1
2 **DOCUMENT 00 91 13**
3

8 ADDENDUM NO.1 Date: 08.02.21
9

10 RE: SAUK COUNTY COURTHOUSE AND HUMAN SERVICES BUILDING RENOVATIONS
11 515 OAK STREET, BARABOO, WI 53913 and
12 425 6TH STREET, REEDSBURG, WI 53959
13

1 LOWER LEVEL DEMOLITION PLAN - LIGHTING
E101.2 SCALE: 1/8" = 1'-0"

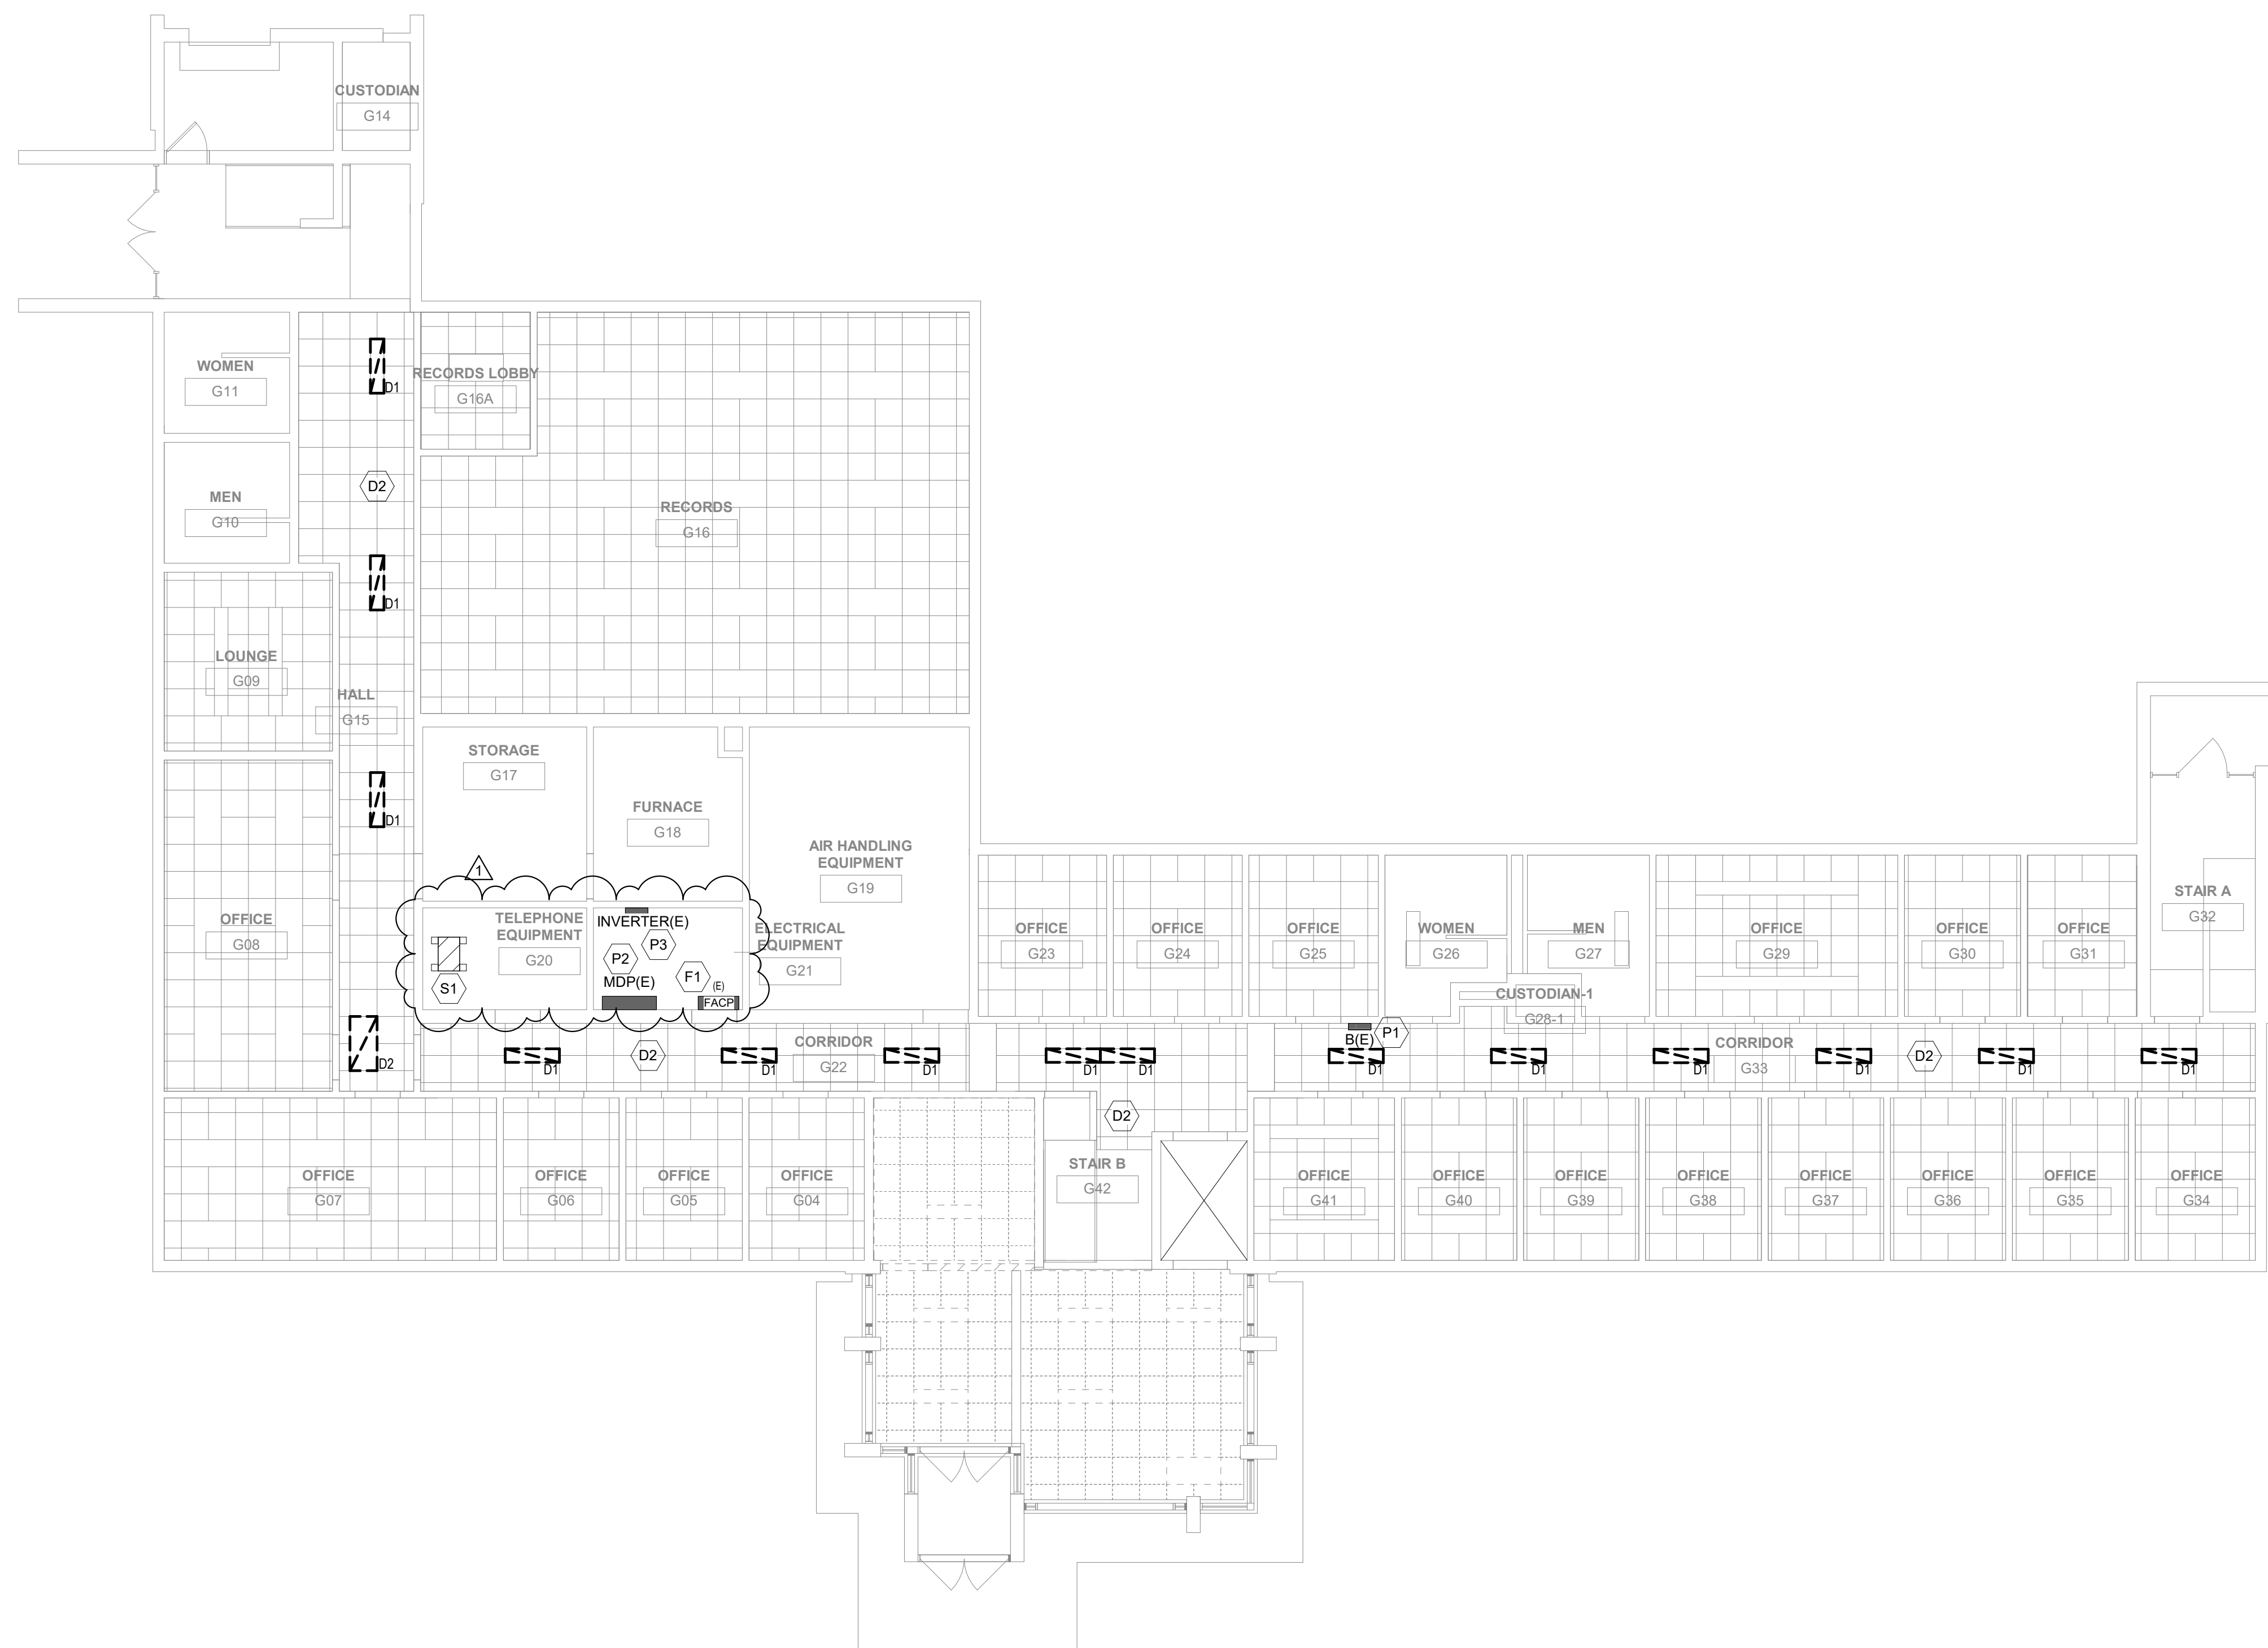
- 56 a. Replace sheet E101.2 in its entirety with attached E101.2
- 57 b. Revised electrical and data panels.
- 58 c. Revised Keyed notes.
- 59
- 60 24. SHEET E102.2, LOWER LEVEL PLAN – LIGHTING

1 LOWER LEVEL PLAN - LIGHTING
E102.2 SCALE: 1/8" = 1'-0"

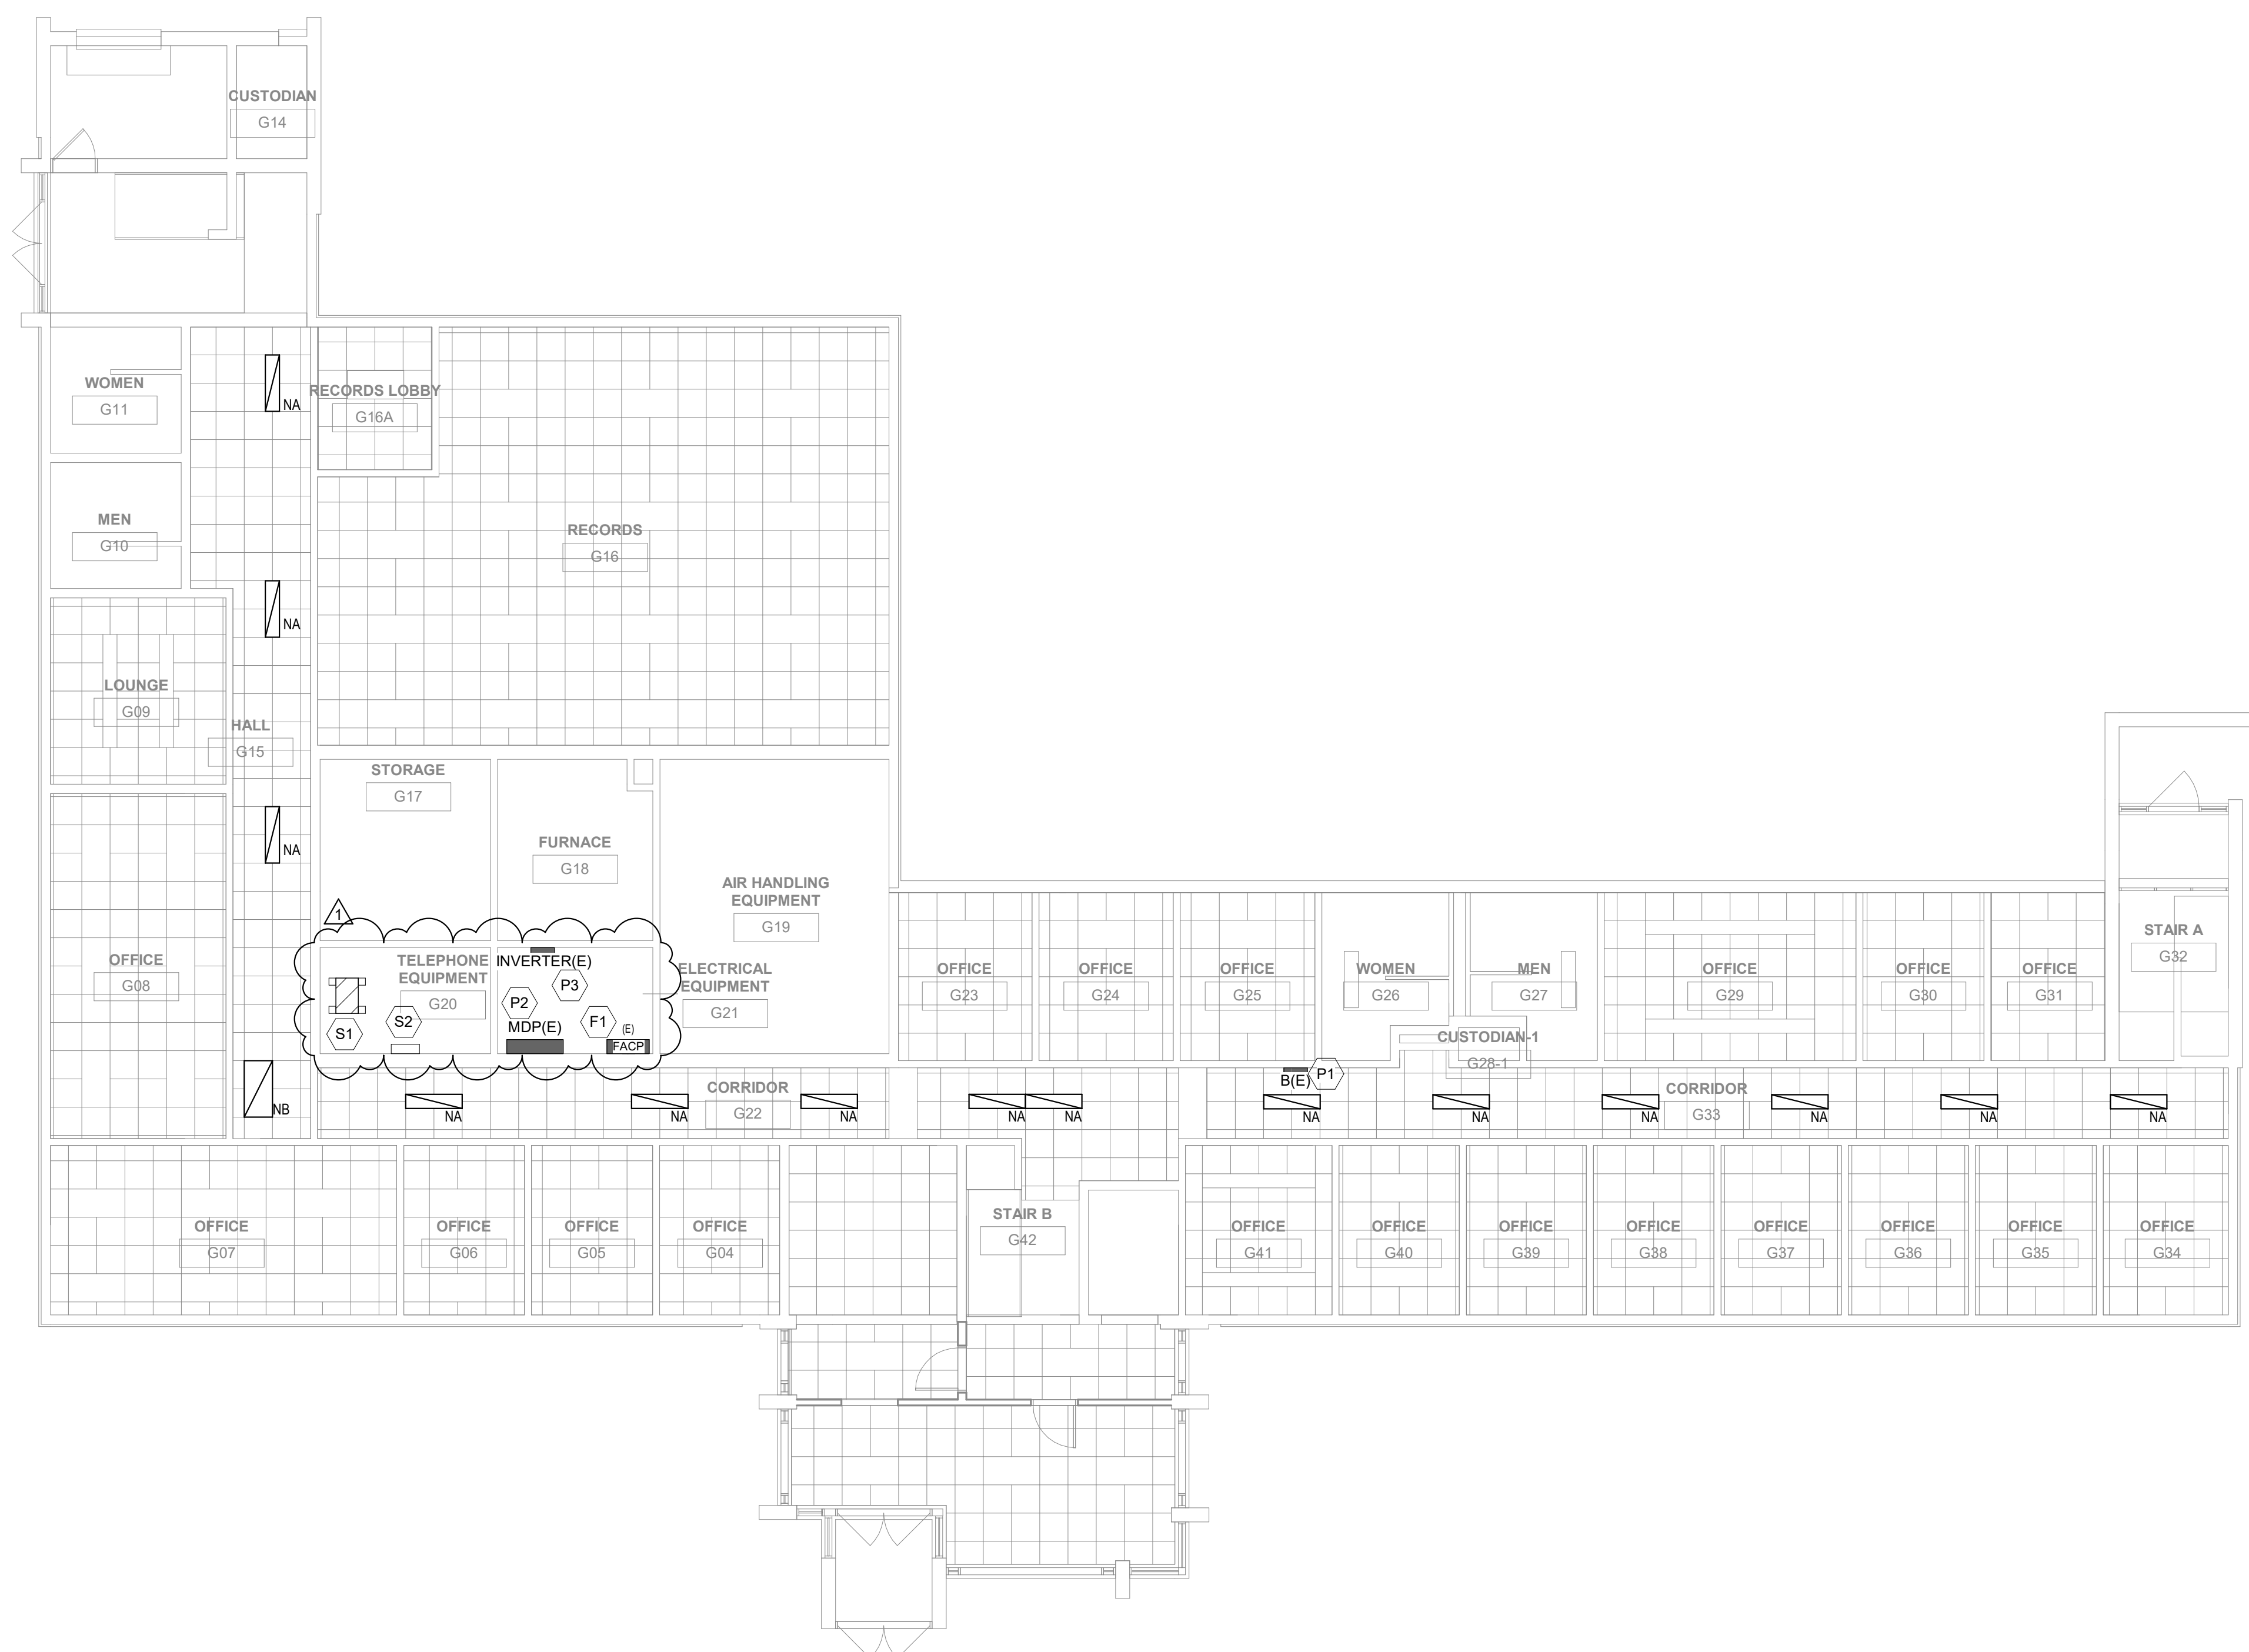
- 1 a. Replace sheet E102.2 in its entirety with attached E102.2
- 2 b. Revised electrical and data panels.
- 3 c. Revised General and Keyed notes.
- 4
- 5 25. SHEET E103.2, MAIN LOBBY PLANS – ELECTRICAL
- 6 a. Replace sheet E103.2 in its entirety with attached E103.2.
- 7 b. Revised General and Keyed Notes.
- 8 c. Revised Main Lobby Plan – Lighting.
- 9 d. Revised power & systems demolition plan and plan.
- 10
- 11 26. SHEET E104.2, UPPER LEVEL PLANS – ELECTRICAL
- 12 a. Replace sheet E104.2 in its entirety with attached E104.2.
- 13 b. Revised General Notes.
- 14 c. Removed equipment connection for plumbing fixture automatic sensors.
- 15
- 16 27. SHEET E106.2, UPPER LEVEL PLAN – LIGHTING
- 17 a. Replace sheet E106.2 in its entirety with attached E106.2
- 18 b. Revised General Notes.
- 19
